Service Tips DLP board PLM

Created by: Lab.gruppen AB Service Department

Reference no: DLP board PLM

Examples of unsoldered pins

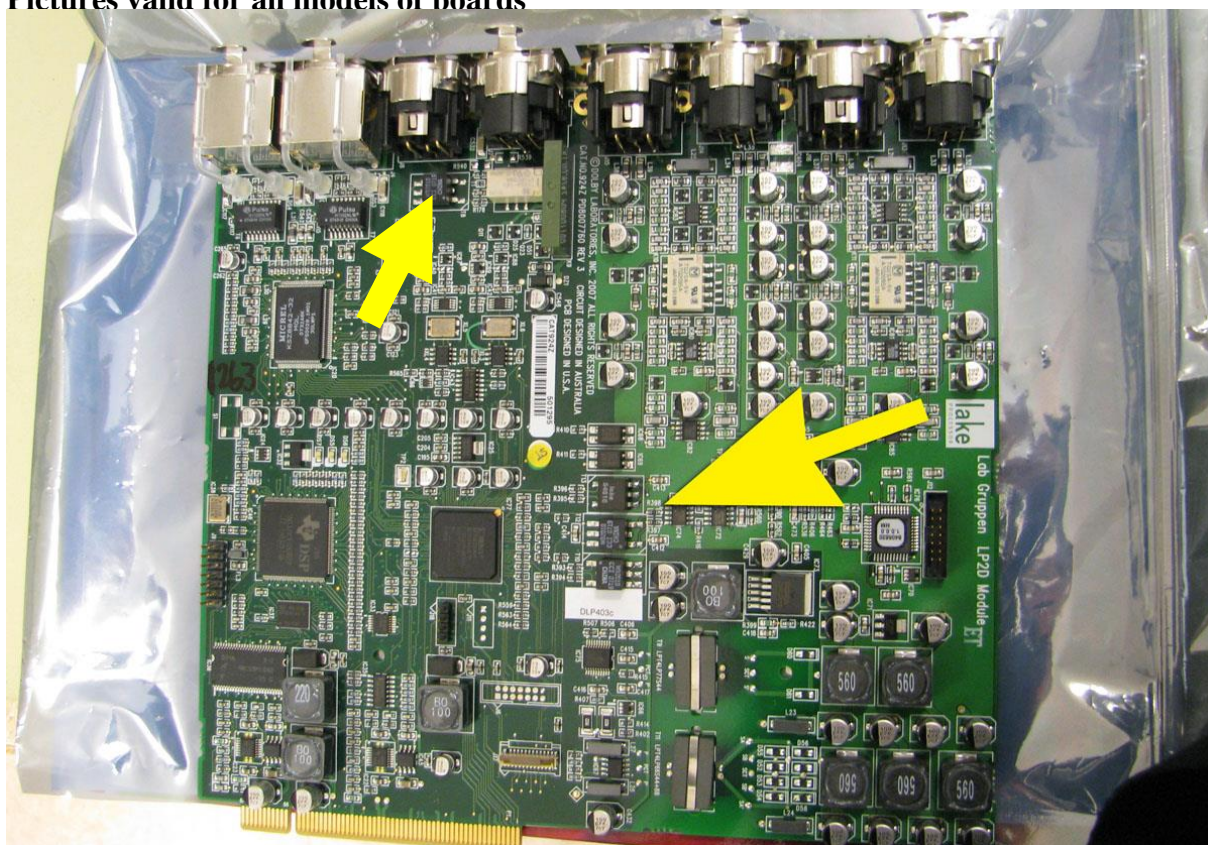
Display says "analogue input fault".

The soldering can look ok but when checking close one or more pins at the transformer is not properly soldered. See pictures for example.

Check soldering at transformer, see picture. Re-solder pins at transformer.
